RS-03-163

Subject: Response to Request for Additional Information Regarding the Quad Cities Nuclear Power Station, Units 1 and 2, Fourth Interval Inservice Inspection Program Plan

ATTACHMENT 1
Response to Request for Additional Information

Relief Request Number I4R-05, Revision 1

FIGURE I4R-05.2

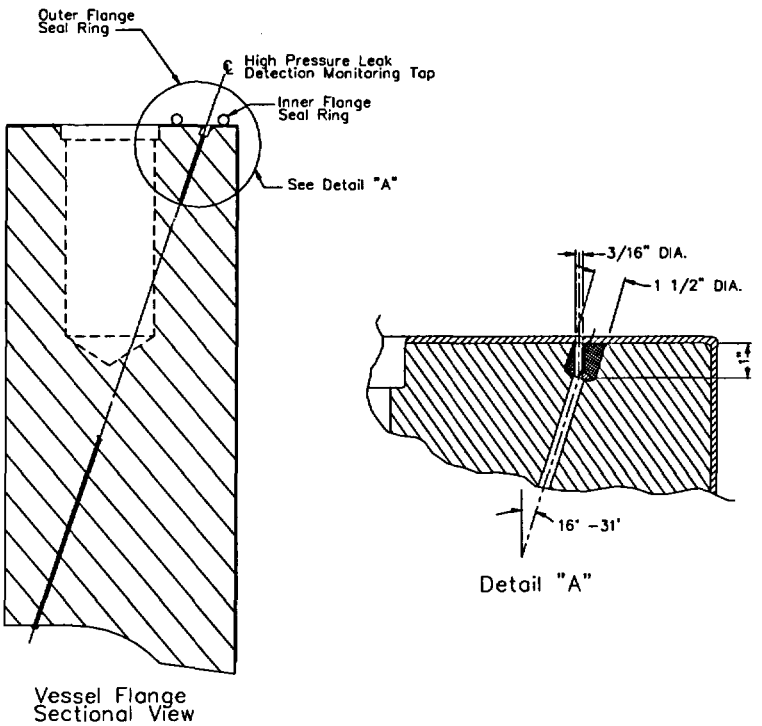
The basis states that the alternative provides an acceptable level of quality and safety, but the majority of the discussion focuses on the difficulty and impracticality of performing the examination by summarizing at the end of your discussion by stating: "It is impractical to purposely fail the inner O-ring in order to perform a test." Please demonstrate why the alternative provides an acceptable level of quality and safety. Secondly, has this configuration been tested in the past, and if so, was it successful or unsuccessful? If it was not tested in the past, has relief previously been granted, and if so, please provide previous relief request information on this weld along with NRC evaluation.

The Reactor Pressure Vessel Head Flange Leak Detection Line is separated from the reactor pressure boundary by one passive membrane, a silver plated O-ring located on the vessel flange. A second O-ring is located on the opposite side of the tap in the vessel flange (See Figure I4R-05.2). This line is required during plant operation in order to indicate failure of the inner flange seal O-ring. Failure of the O-ring would result in the annunciation of a High Level Alarm in the control room. On this annunciation, control room operators would quantify the leakage rate from the O-ring and then isolate the leak detection line from the drywell sump by closing the AO 1(2)-220-51 valve (see Figure I4R-05.1). This action is taken in order to prevent steam cutting of the O-ring and the vessel flange. Failure of the inner O-ring is the only condition under which this line is pressurized.

The configuration of this system precludes manual testing while the vessel head is removed because the odd configuration of the vessel tap (See I4R-05.2), combined with the small size of the tap and the high test pressure requirement (1000 psig minimum), prevents the tap in the flange from being temporarily plugged. The opening in the flange is only 3/16 of an inch in diameter and is smooth walled making a high pressure temporary seal very difficult. Failure of this seal could possibly cause ejection of the device used for plugging into the vessel.
